City of Oakley
ADDENDUM NO. 2 to contract documents for
CIP 250 – Laurel Road Resurfacing Project (Empire Ave. to O’Hara Ave.)

BID OPENING DATE: June 29, 2021 2:00 PM

Notice is hereby given that the following clarifications and revisions are made to the above referenced contract documents:

1
19 PAVEMENT TREATMENT ALTERNATIVE 3: SURFACE RECONSTRUCT
REMOVE 6-7" AC AND REPLACE WITH 2.5" RHMA OVER 4.5" HMA
N.T.S.

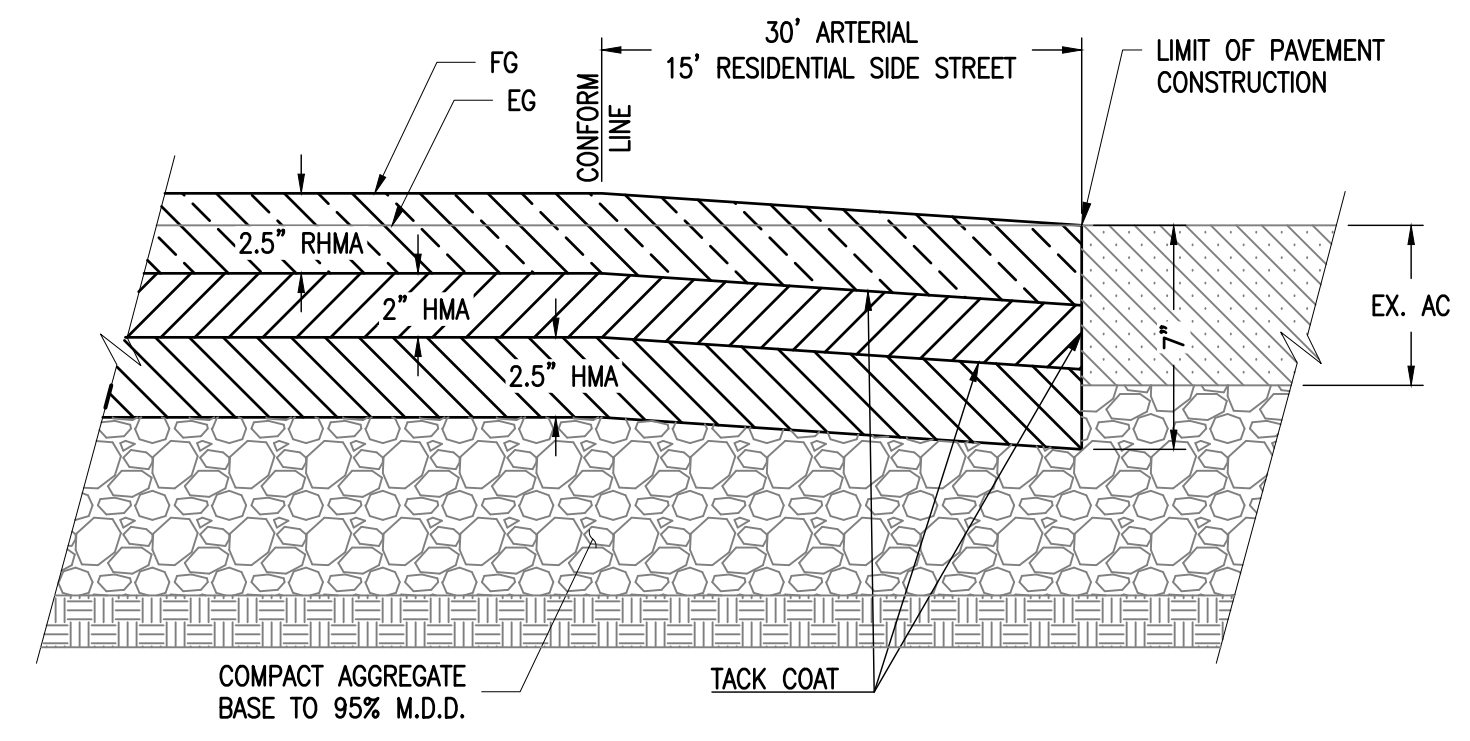
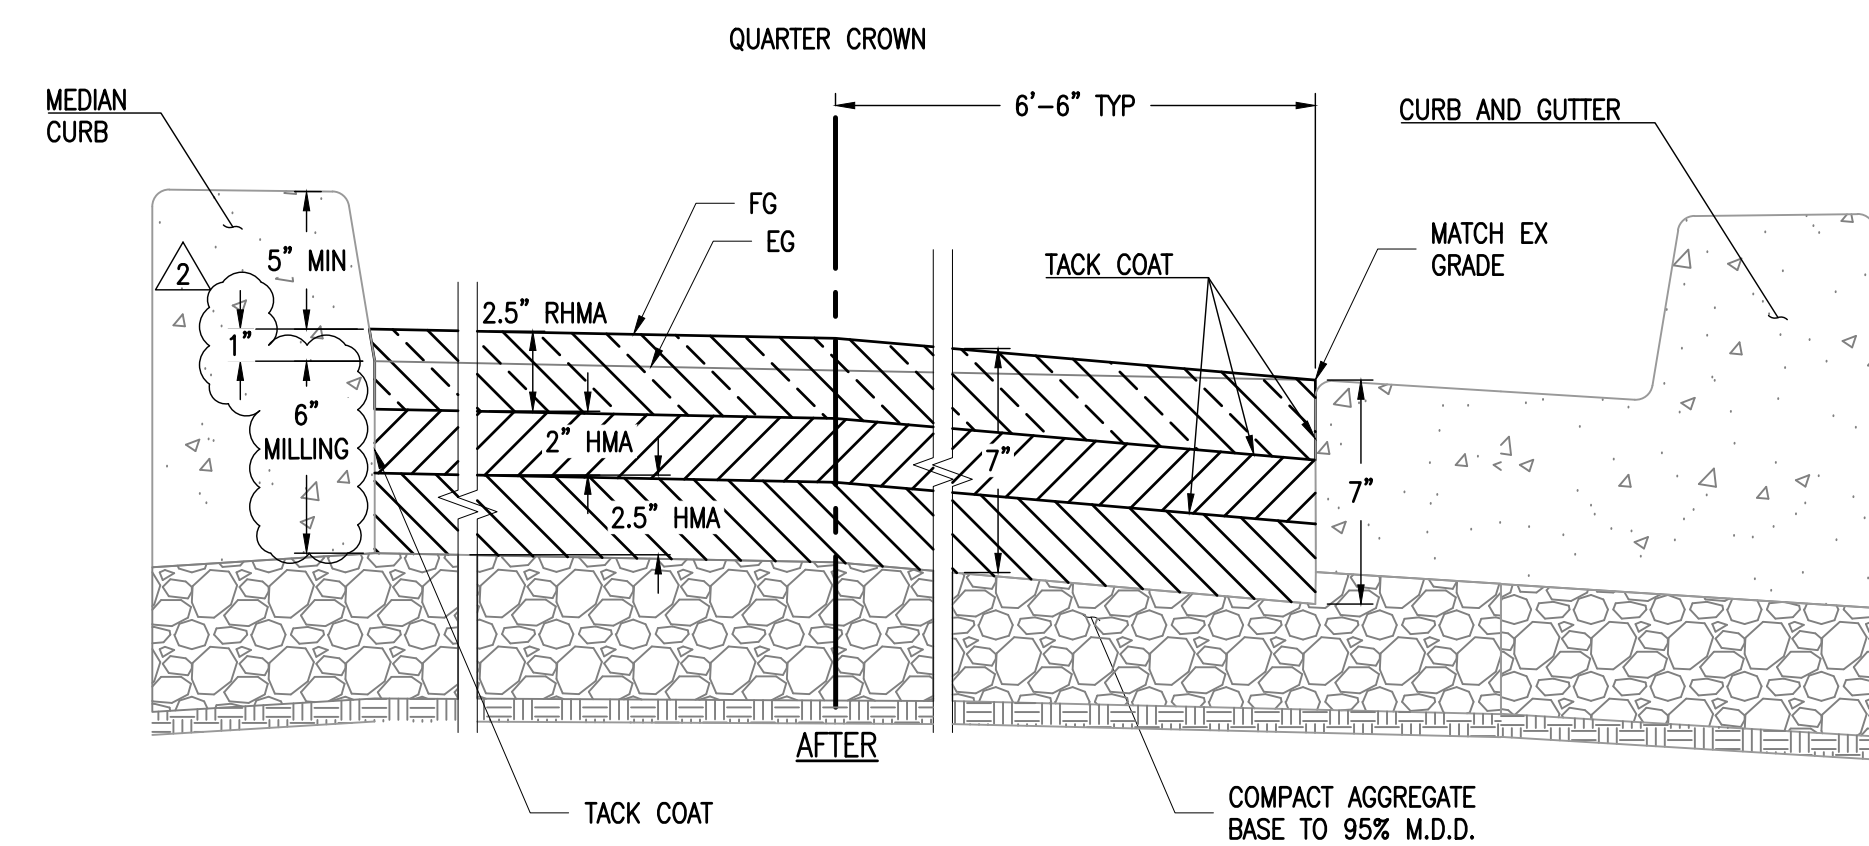
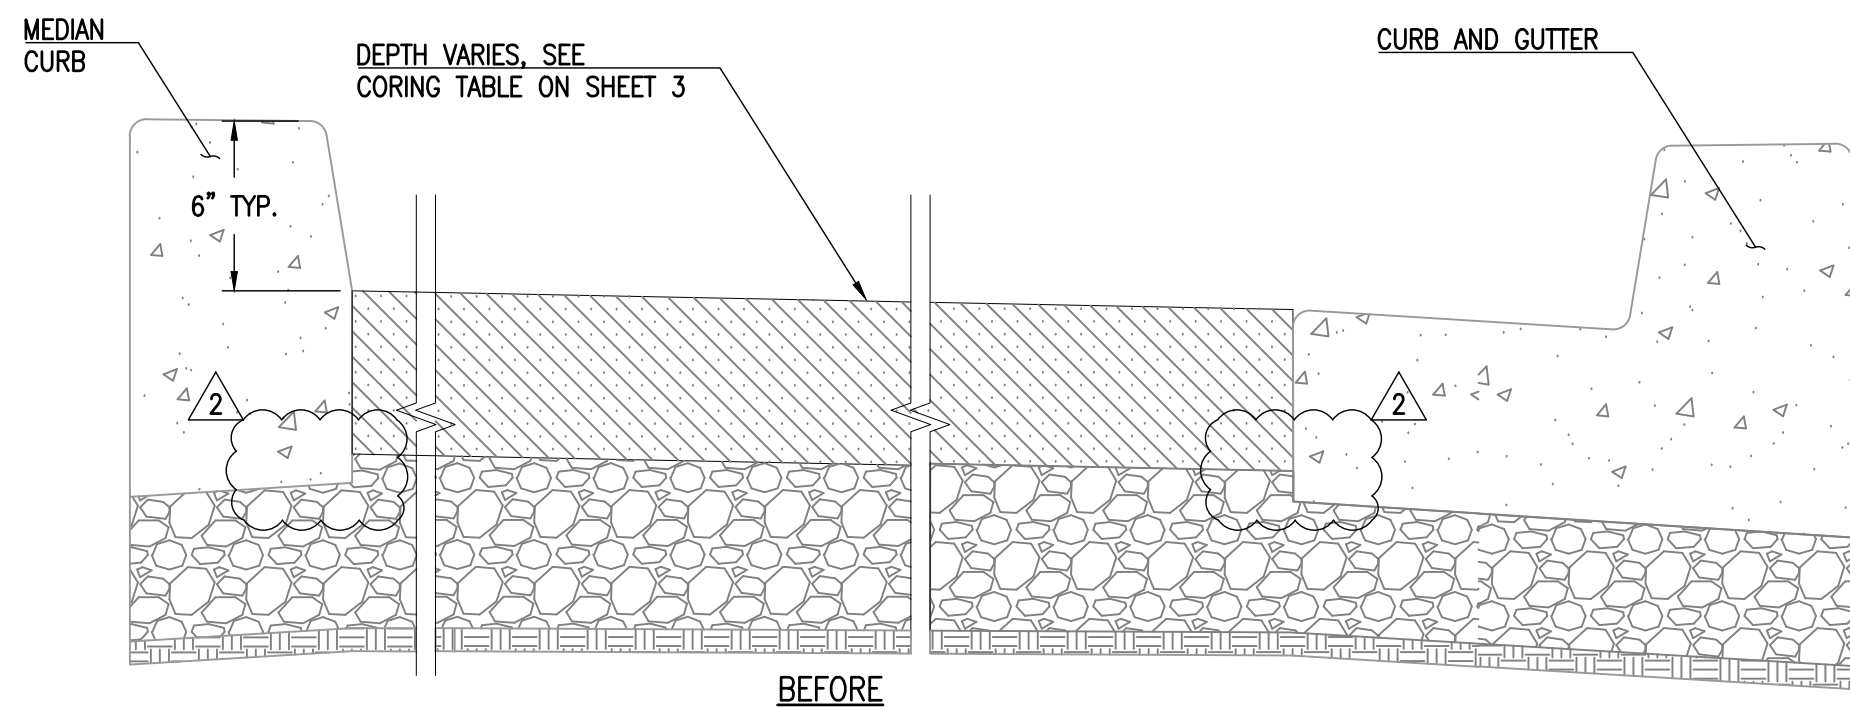
Details Sheet 1 (18 of 49) and 2 (19 of 49) are modified as attached.
